## MERCEDES 722.6 VARIETY OF SHIFT AND/OR TCC COMPLAINTS

Copyright © 2005 ATSG

Figure 1

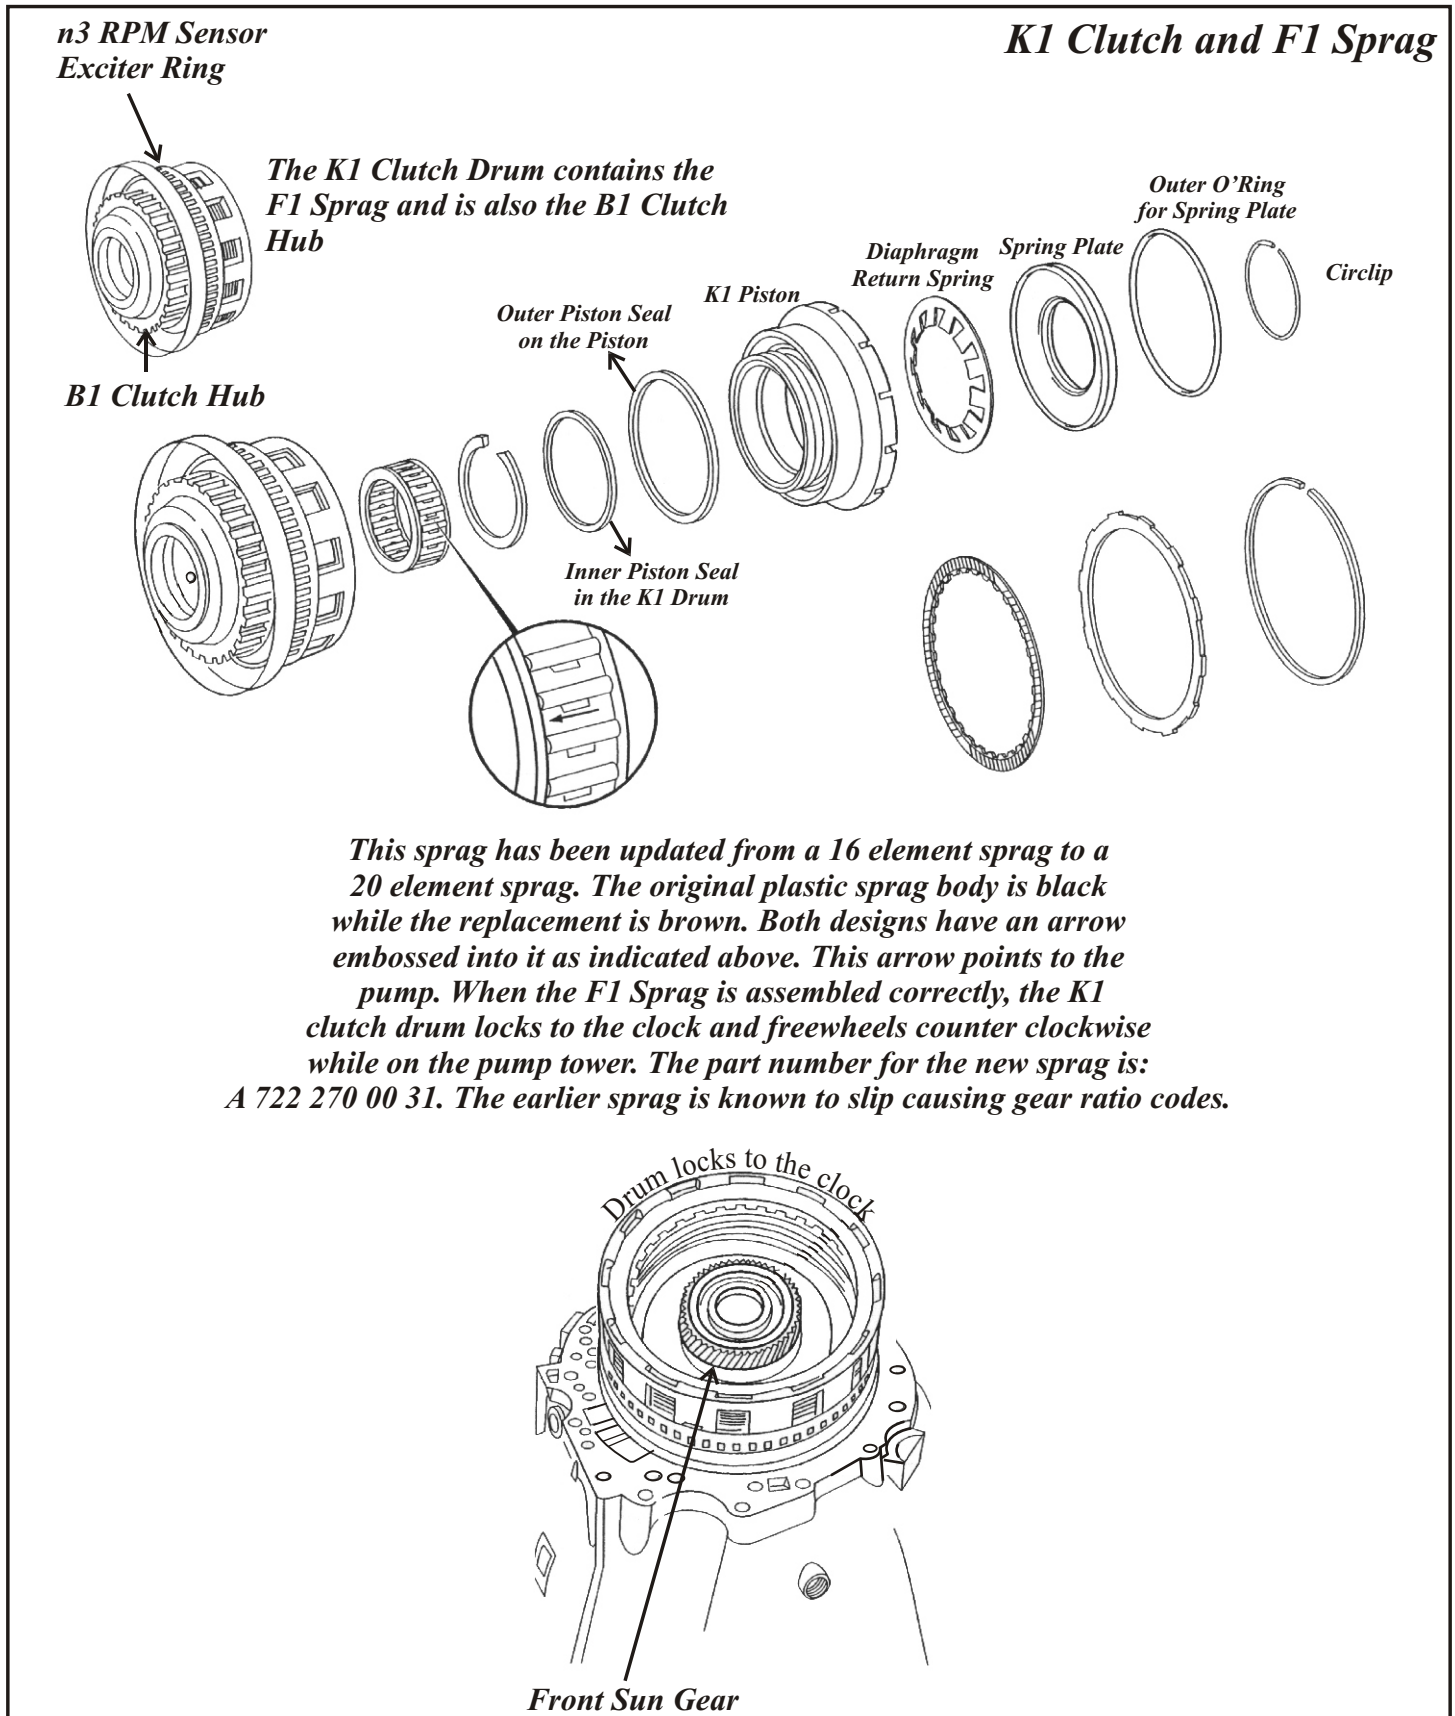
**CAUSE:** Low retention of OEM scarf cut sealing rings for the K2 clutch drum on the input shaft as well as the output shaft rings for the K3 clutch drum (See Figure 1). The rings on the input shaft could cause a loss of pressure for the K2 clutch and/or the converter clutch while the rings on the output shaft could lose K3 clutch pressure. The severity of the leak would determine the degree of shift complaints.

**CORRECTION:** Since pressure testing with a gauge is not available, it is highly recommended to update the rings to the newer style as seen in figure 1 and replace the sprags, especially if the F1 sprag has 16 elements and the F2 has 14. These are early sprags and are prone to slipping. Both sprags have been updated to 20 elements each (See Figure 2 and 3).

Figure 2

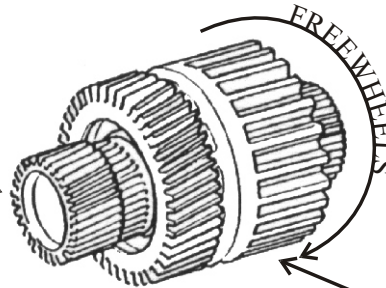
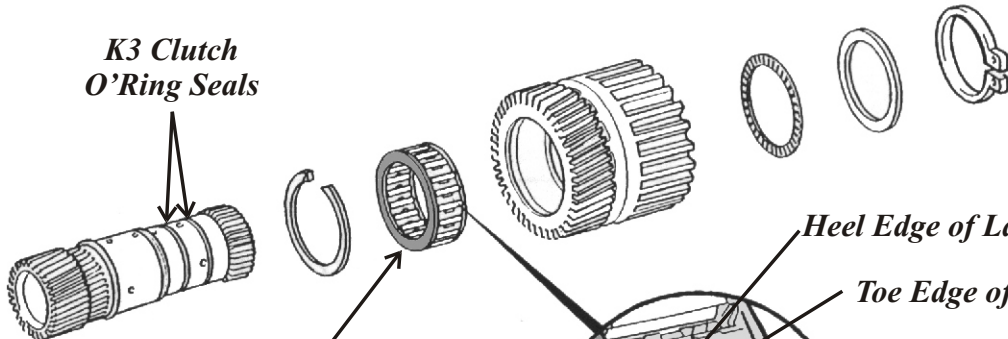
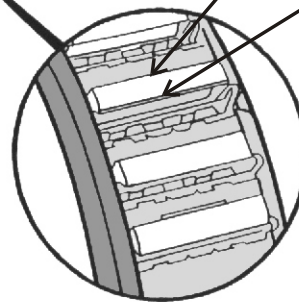
It should be noted that the F1 and F2 sprags are also known to slip causing shift complaints and implausible shift errors (gear ratio errors) especially if they are not the later 20 element design.

This sprag has been updated from 14 elements to 20. The new 20 element sprag part number is A 220 270 01 31. It is very common to find that some of the elements have fallen out from the retaining cage and laying loose in the package. This does not mean the sprag is defective. It is imperative that you insert the element back into the cage slot correctly. The shorter foot of the element faces the inner race as seen to the right. With the brass cap to the left as seen in the enlarged circled view, the toes face down. The early design sprag is known to slip causing gear ratio codes.
